Form 3160-5
(August 2007)UNITED STATES
DEPARTMENT OF THE INTERIOR
BUREAU OF LAND MANAGEMENTFarmington Field Office
Bureau of Land ManagementFORM APPROVED
OMB No. 1004-0137
Expires: July 31, 2010**SUNDRY NOTICES AND REPORTS ON WELLS**
Do not use this form for proposals to drill or to re-enter an abandoned well. Use Form 3160-3 (APD) for such proposals.

San Juan 29-7 Unit 111

30-039-21332

Attachment to notice of Intent to Recomplete & Commingle

Well Name: SAN JUAN 29-7 UNIT #111

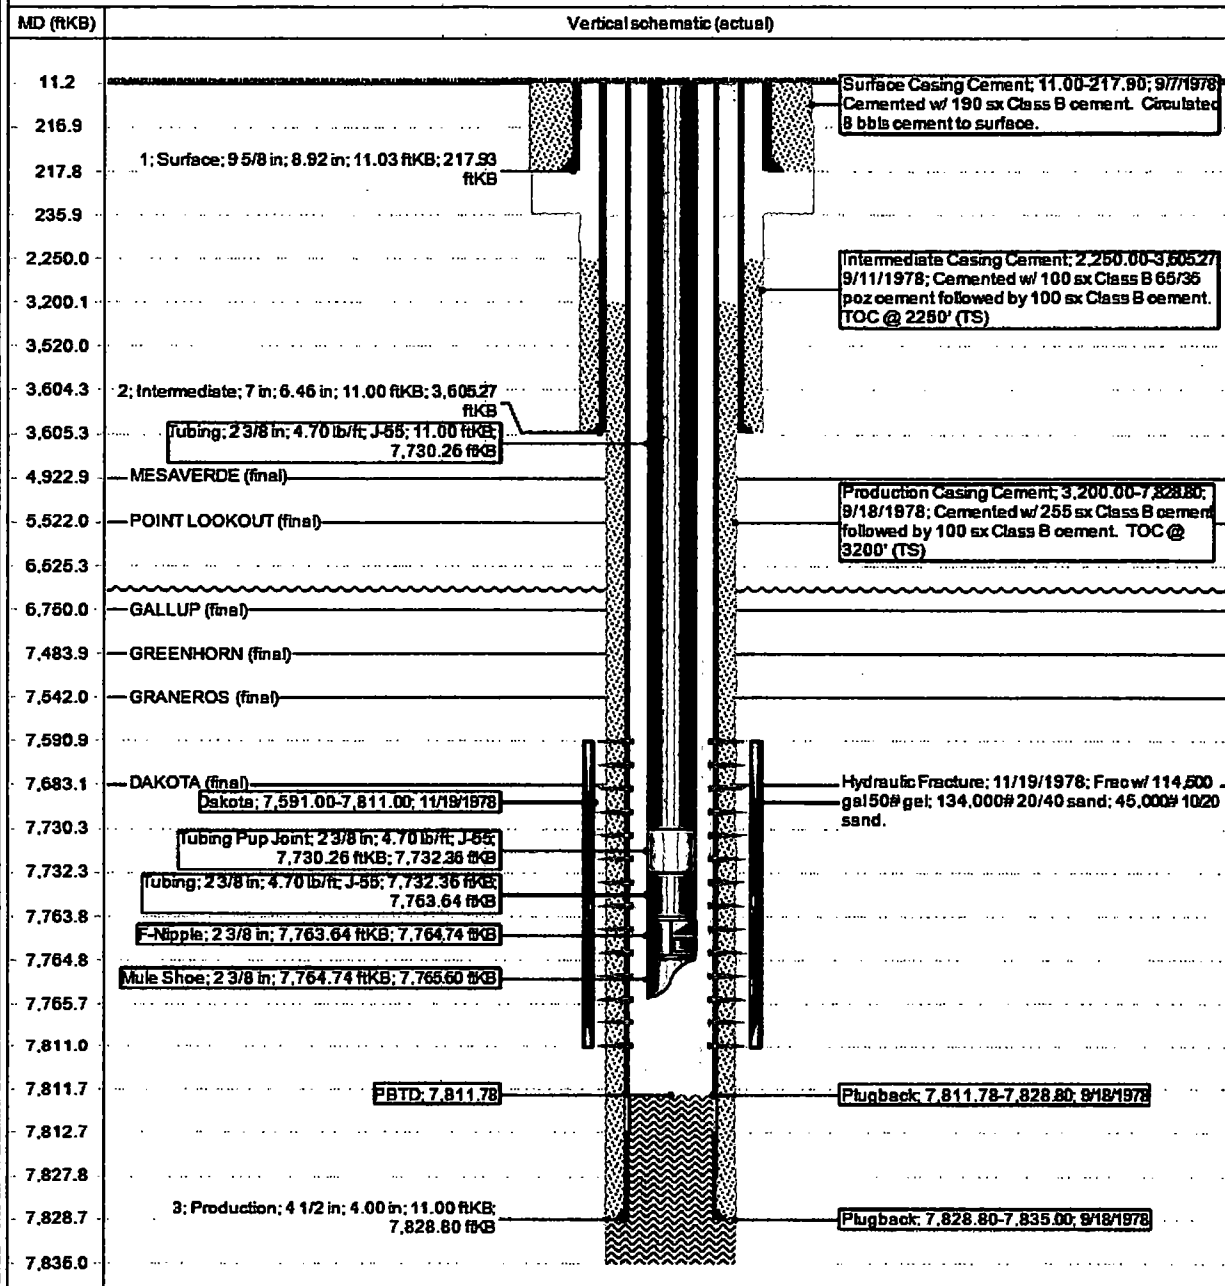
- a) Upon rigging up, record Bradenhead pressure and monitor same during recompletion operations. Notify BLM and NMOCD if anomalous pressure changes occur. Provide monitoring results in the subsequent Report of Operations.
- b) Casing pressure test for fracture stimulation operations cannot exceed the internal yield strength of the casing including a 20% safety factor unless a waiver is granted. Stimulation operations cannot exceed this test pressure.
- c) CIBP for base of fracture stimulation to be set less 50' above top existing perforation.
